TECHNICAL ADVISORY COMMITTEE

MEETING #6 SUMMARY

DATE: Tuesday, August 6 2019, 1:00 p.m. – 3:00 p.m.

MAIN STREET SAFETY PROJECT | 20th Street to 72nd Street

Alternative Solution A (Minimize Conflicts)

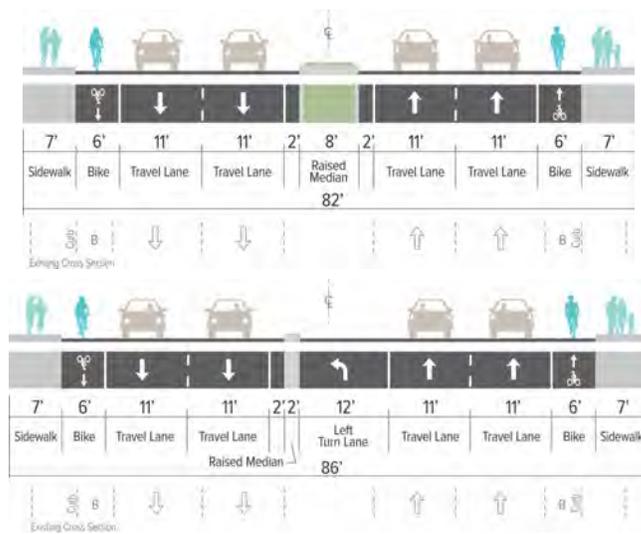
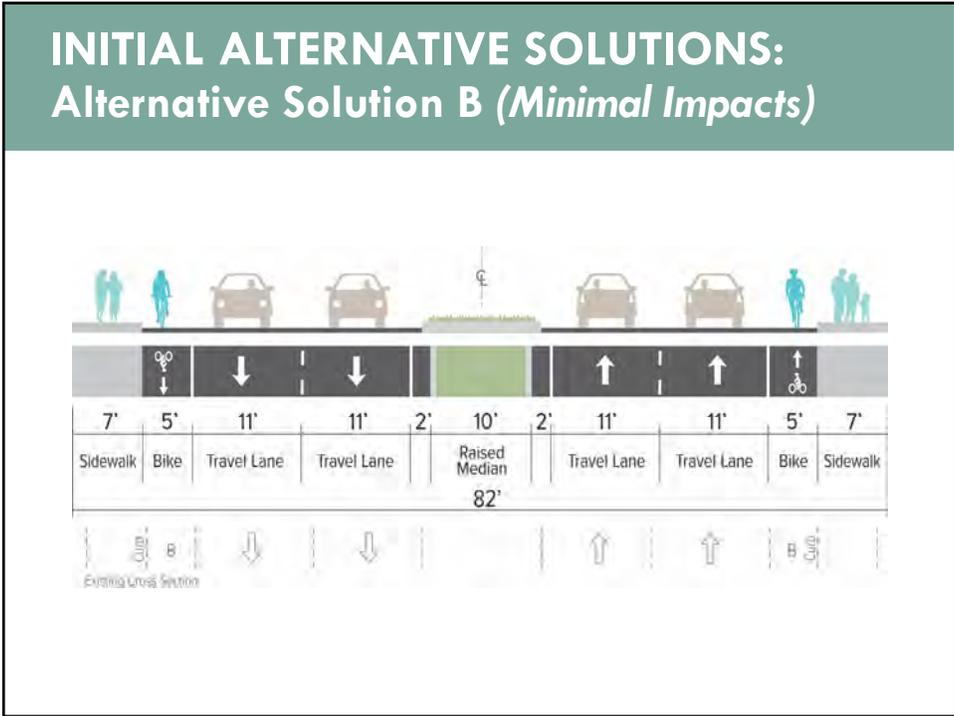
John introduced the cross-section for Alternative Solution A. Kristi asked if the shy distance next to the median could be spread to the other travel lanes. John noted that is the ODOT standard design. Molly Markarian, City of Springfield, noted that the design exception process would be discussed by the City and ODOT at a later date.

The map of median locations and openings in the medians for Alternative Solution A was shared. There was discussion among the TAC on where it is legal or illegal to make U-turns. It was noted that U-turns are only allowed at signalized intersections if it is signed as allowed. It was also noted that U-turns are illegal in-between intersections (mid-block). There was some uncertainty to the legality of a U-turn at an unsignalized intersection. [Note: following the meeting, it was confirmed that U-turns at unsignalized intersections can be allowed by law.]

- **Alternative Solution A:**
 - Alternative A could be adjusted to include a buffered bike lane and/or landscape strip, since a buffered bike lane is not shown on any other alternatives. The buffered landscape strip could be dropped at locations where there are left turn lanes to minimize the right-of-way impacts.

- There was also a suggestion to modify Alternative A to have 6-foot sidewalks, 5-foot raised cycle track, and 1-foot shy.
 - Consider moving a foot of shy distance next to the median to the outside travel lane to provide more space for freight/transit vehicles next to bicyclists. You could also add a two-foot buffer to the bike lanes in this alternative.

- When messaging, we need to reinforce that Alternative A would have little impact on adjacent properties, while others may have more significant impacts.

Alternative Solution D (Active Transportation Enhanced)

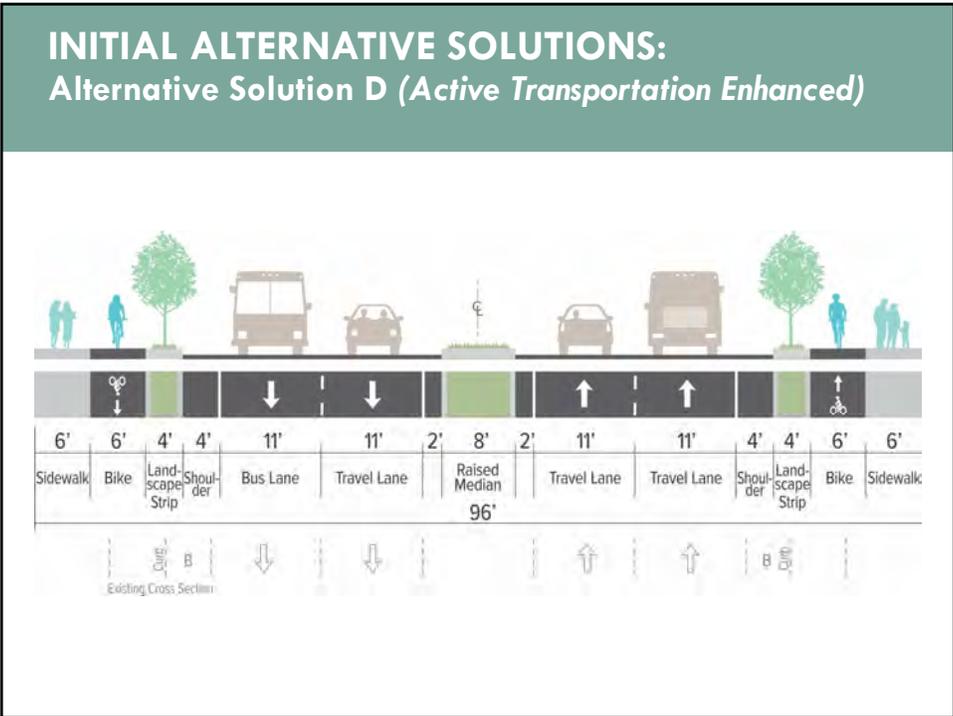
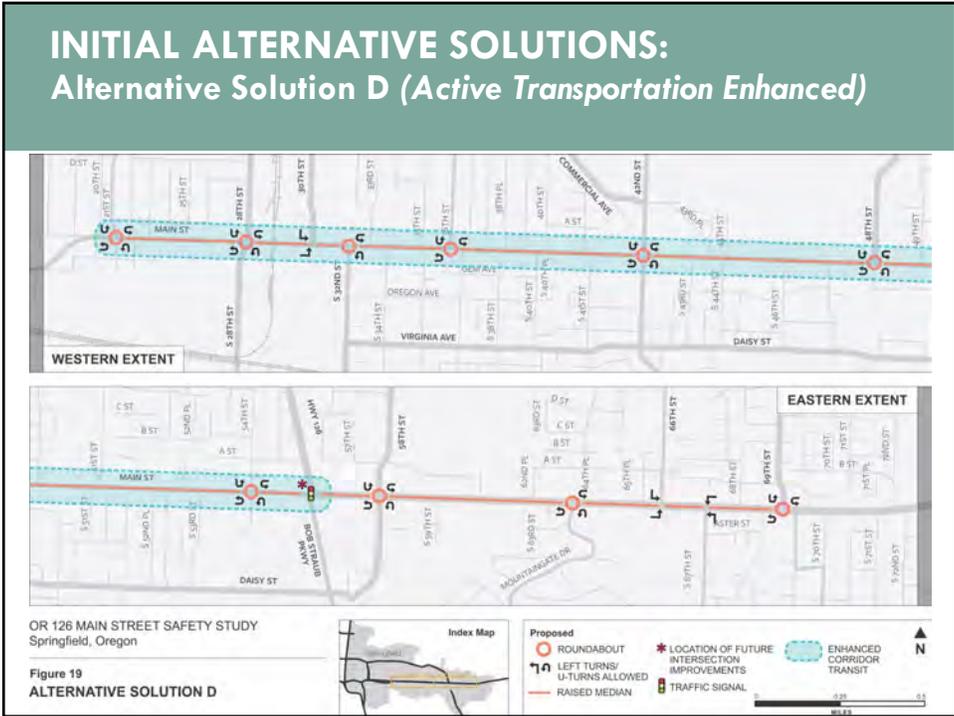
John introduced Alternative Solution C and then Alternative Solution D. On Alternative Solution D, John asked Carl if a four-foot shoulder was appropriate. Carl said a four-foot shoulder was likely appropriate, but he would be concerned about bicyclist safety with the horizontal separation between vehicles turning into driveways and the cycle track.

On Alternative Solution D, Michael was concerned with people traveling both directions on the cycle track and that the landscape strip will not provide enough space to allow vehicles to store between the travel lane and the cycle track.

- There was concern that Alternative D would have impacts on transit operations. Under the typical cross-section, the bus ramps would drop passengers into the cycle track, which could cause collisions between people biking and transit passengers.

- There is not enough space for a vehicle to store between the cycle track and the travel lane, which is a safety concern for vehicles turning into cyclists or stopping in the travel lane and being rear-ended.

- There was a concern that vegetation (hedges) could obstruct the views of bicyclists.
 - While the cycle track is designed for one-way use, it was noted that it would likely be used bi-directionally, which could be a safety concern. It was noted that the cycle track and sidewalk width does not seem wide enough to accommodate both people walking and biking and that cyclists would use the sidewalk as additional space.

- There was discussion around making Alternative D more of an on-street protected bike lane, but it was noted that this would be difficult given the number of driveways. There would be large stretches of roadway where protection would not be feasible.

- From a transit perspective, 12-foot lanes work well today and would be preferred for transit vehicles.
 - It was noted that the graphic incorrectly labels the left most lane as a “bus lane”, which would need to be fixed.
